**Commonwealth Edison**

April 2, 1984

Subject: Byron Generating Station Units 1 and 2  
Technical Specifications  
NRC Docket Nos. 50-454 and 50-455

This is to provide additional comments and suggestions regarding the proof and review version of the Byron 1 Technical Specifications that was distributed in reference (a). NRC review of specific changes proposed here is necessary before the Technical Specifications can be finalized.

FIGURE 5.1-1

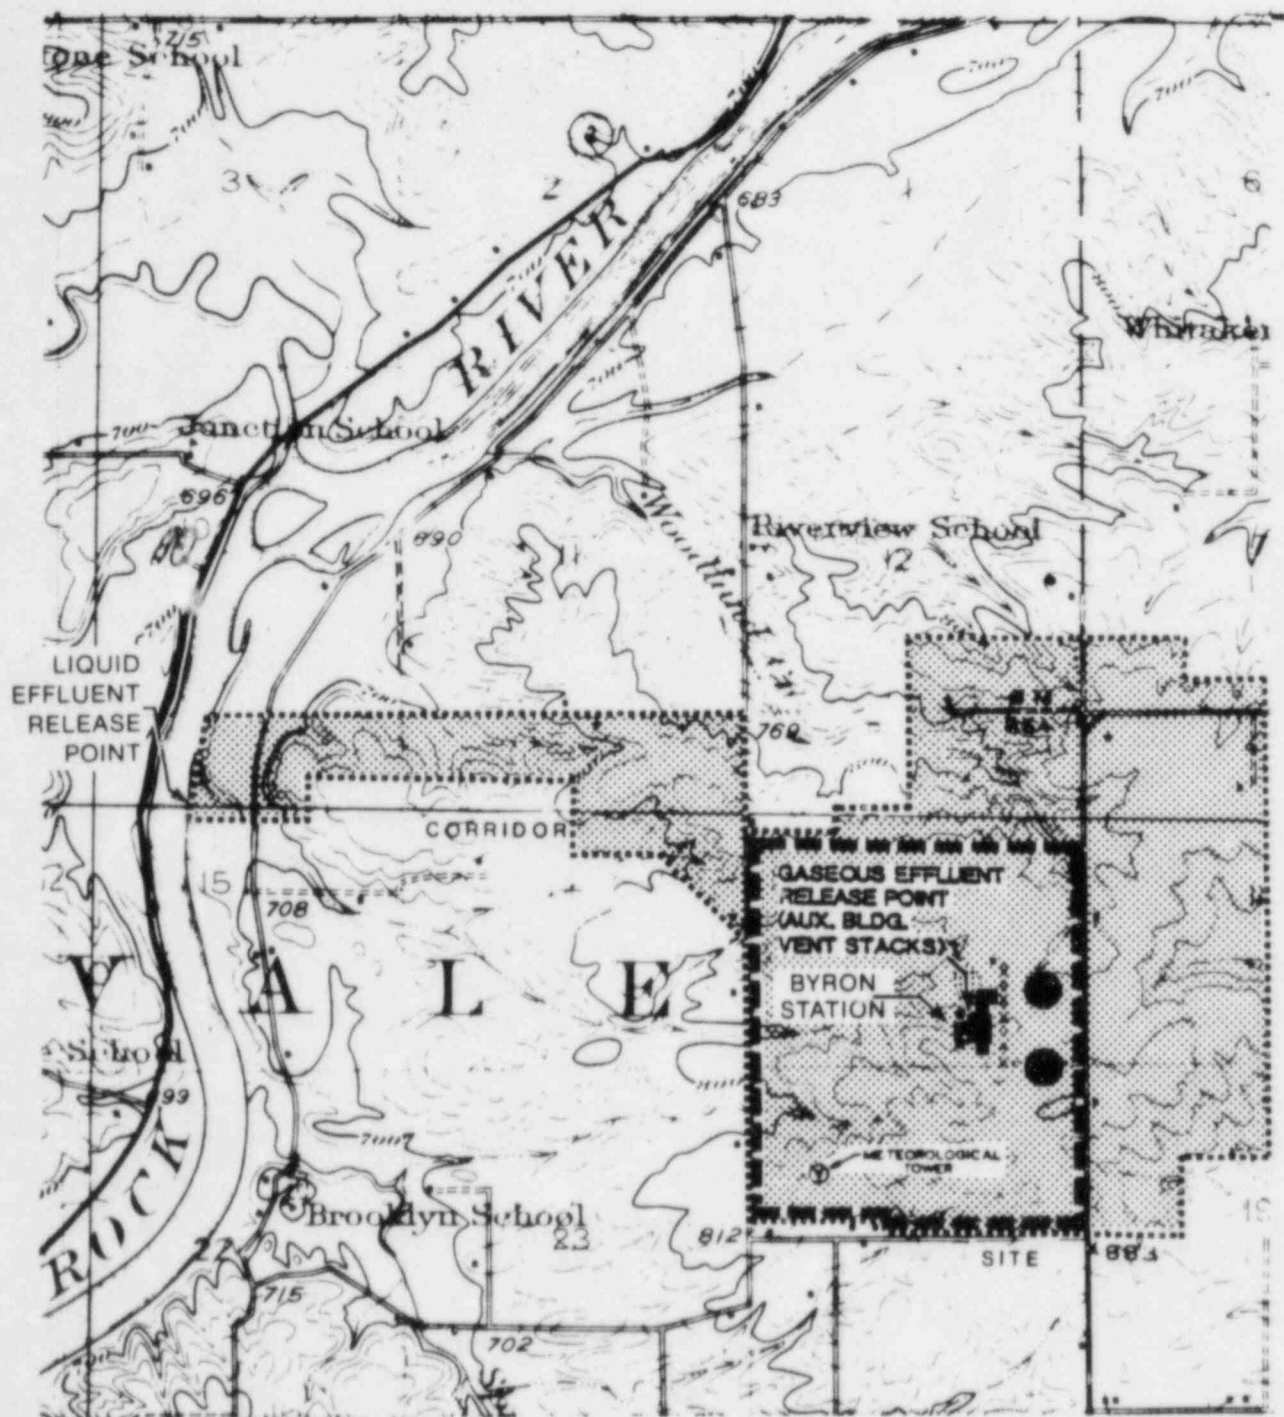
- 1) Figure 5.1-1 (page 5-2) Exclusion Area and Unrestricted Area For Radioactive Gaseous and Liquid Effluents.

This figure replaced old Figure 5.1-1 which did not have meteorological tower on the map.

FIGURE 2.1-1  
REACTOR CORE SAFETY LIMIT - ~~FOUR LOOPS IN OPERATION~~

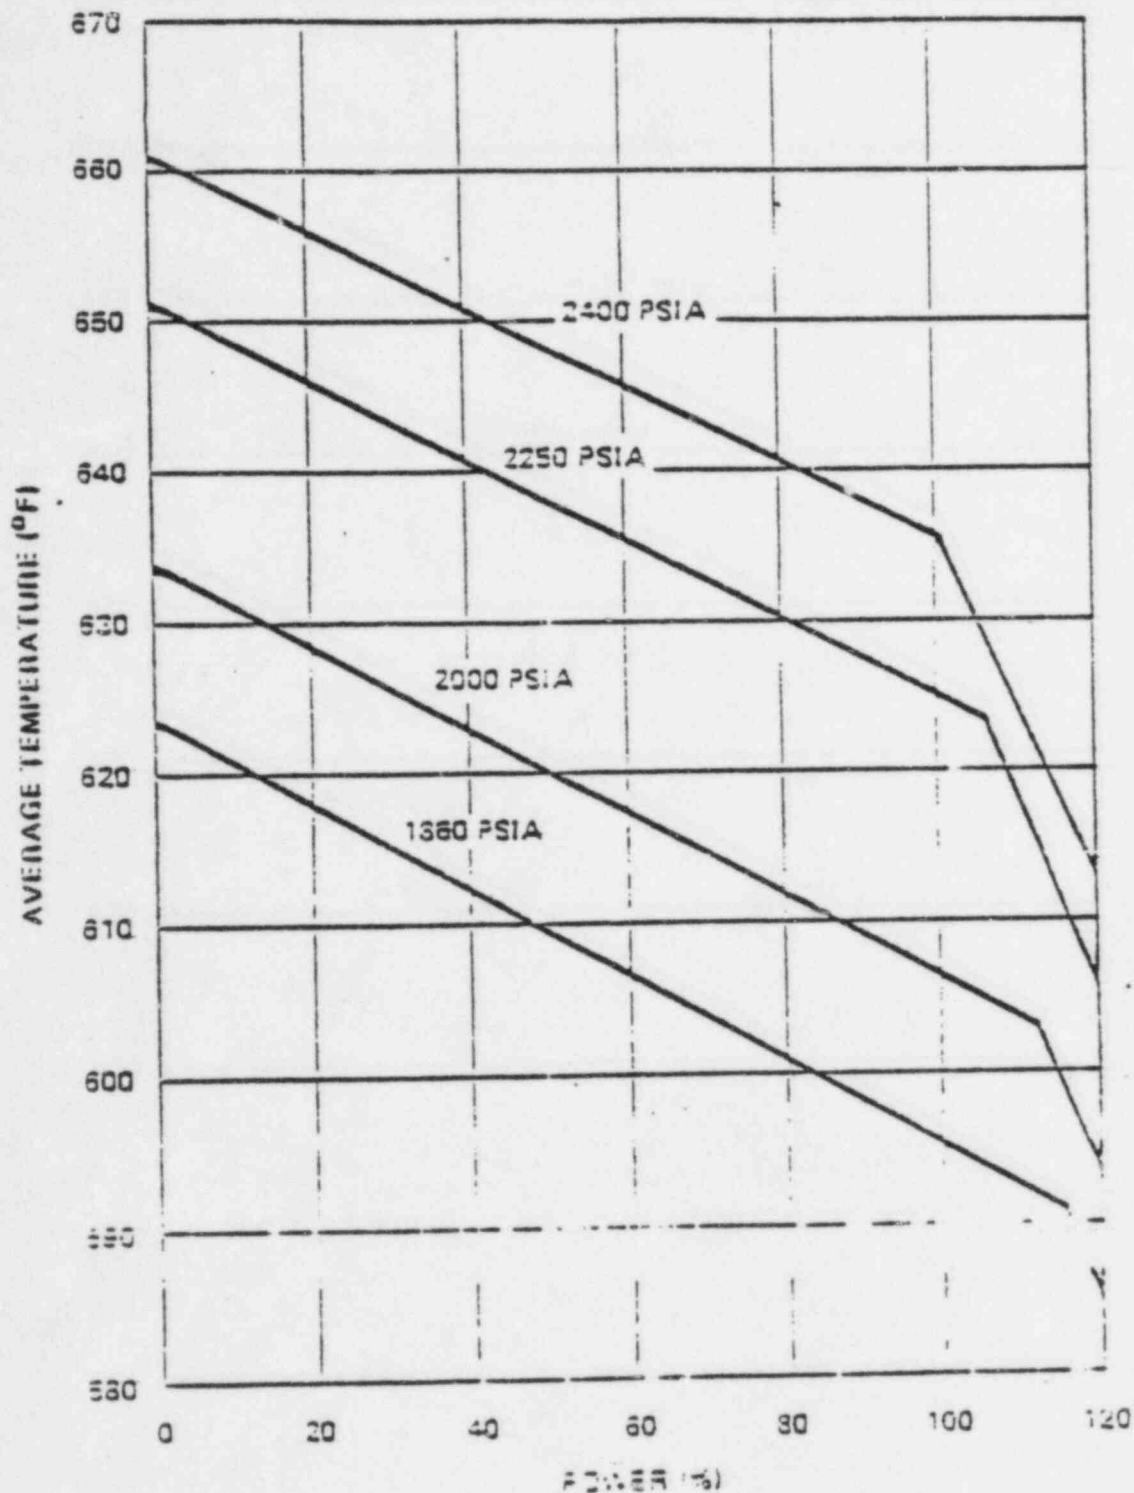
Deleted "Four Loops in Operation". Only one type of Operation.
- 4) Figure 2.1-2 (Page 2-3)

Reference to Specific  
loop should be deleted

FIGURE 3.1-1

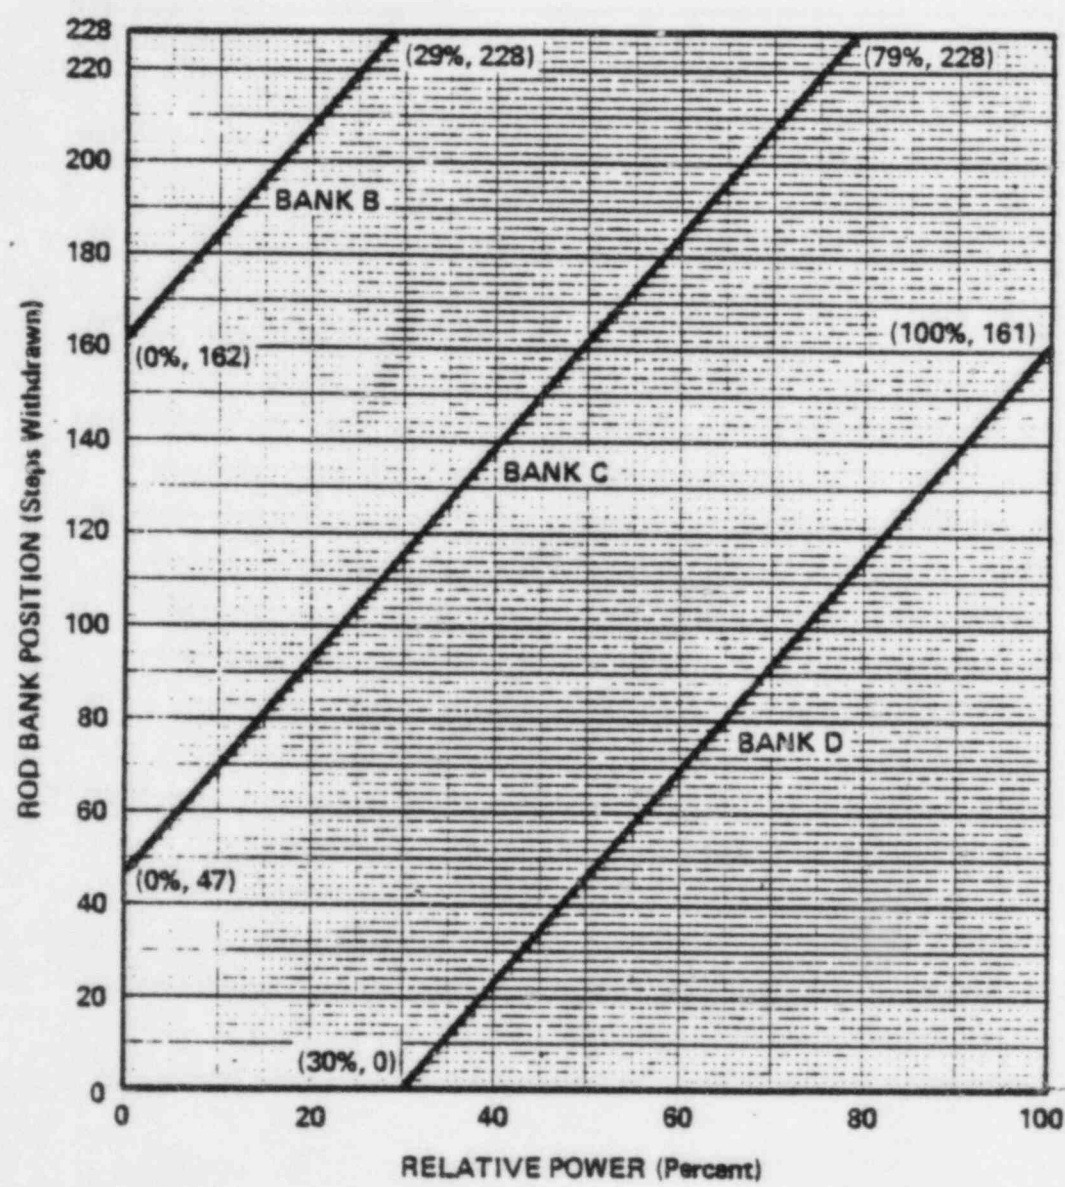
Delete "Four Loop Operation".
- 9) Figure 3.1-2 (Page 3/4 1-23)

ROD BANK INSERTION LIMITS VERSUS THERMAL POWER  
~~FOUR-LOOP OPERATION~~
